Search Result for HOWARD COUNTY

Westcliffe Manor

LOTS 19 THRU 28
 AND PARCELS A-D
WESTCLIFFE MANOR
 SECTION II
 sheet 1 of 2
 Tax Map 9 Parcels 544 & 55
 Fourth Election District
 Howard County, Maryland
 MAR. 27, 1978 Scale: 1"=100'
 F-78-167 1841

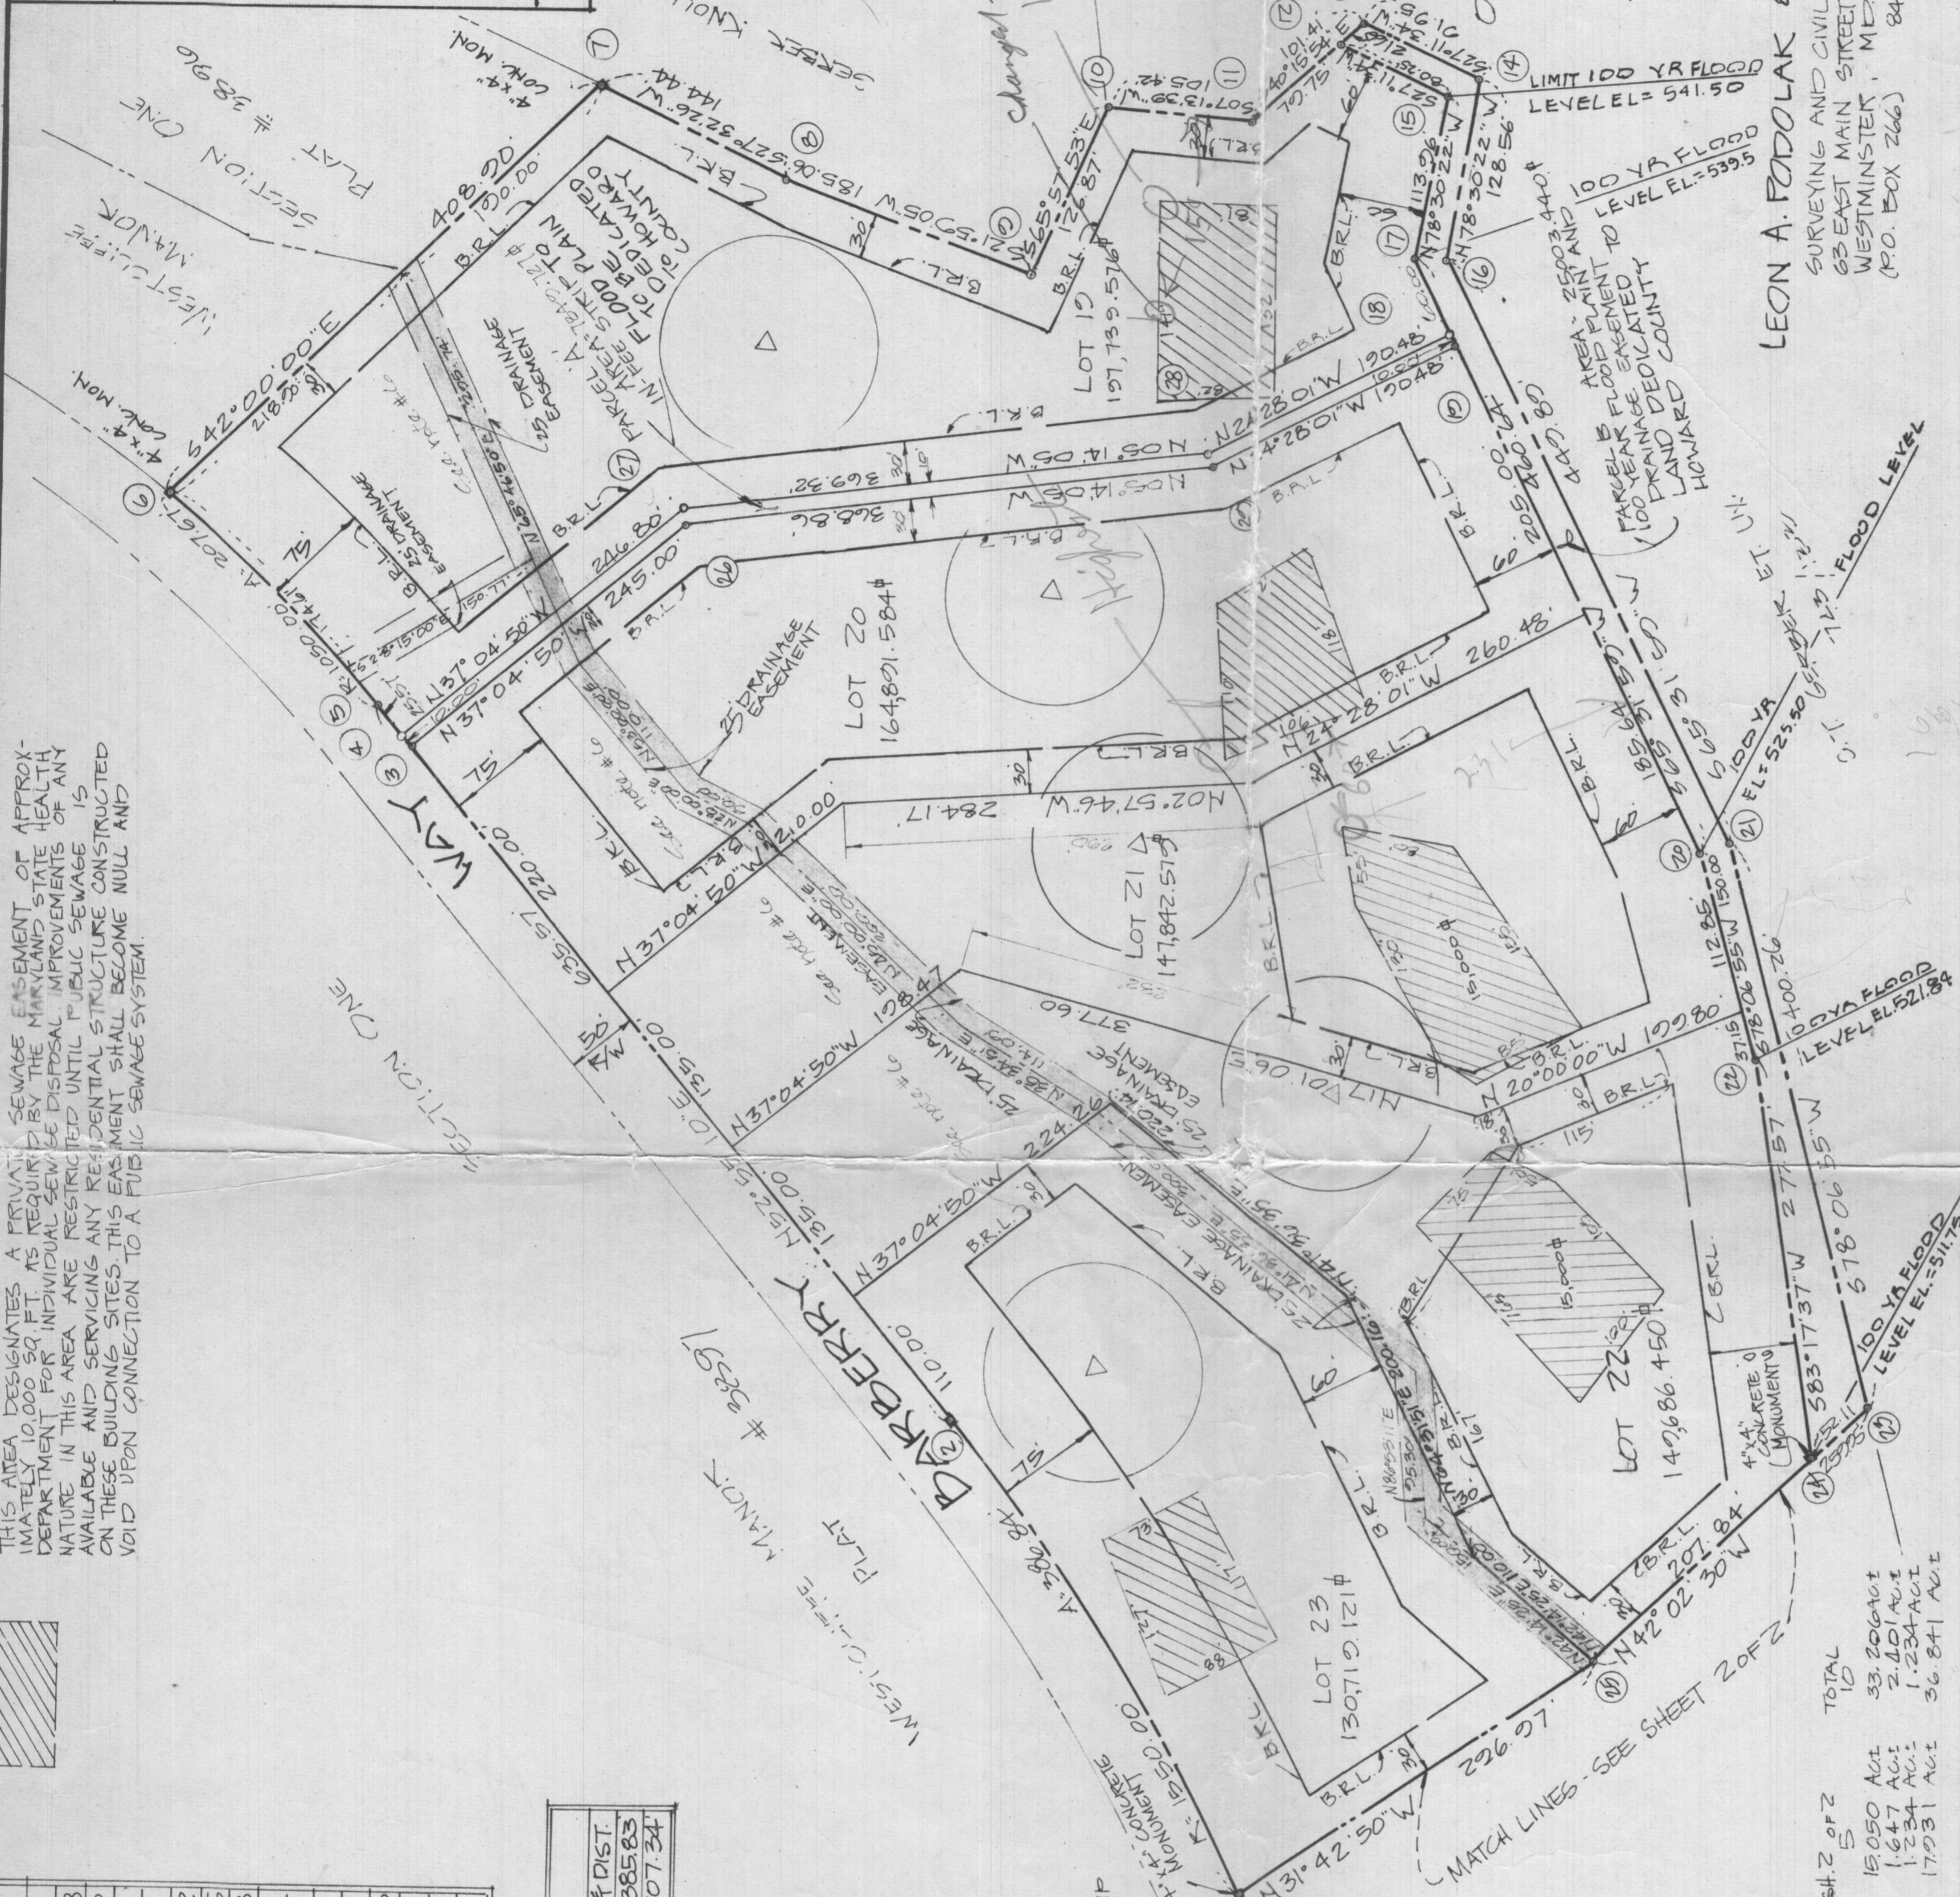
{Engineer called} Section 2
Wheatcliffe Manor
10/25/77 Hold for revised
plans and overlay
of old ^{1st} plat.
C. B. O.
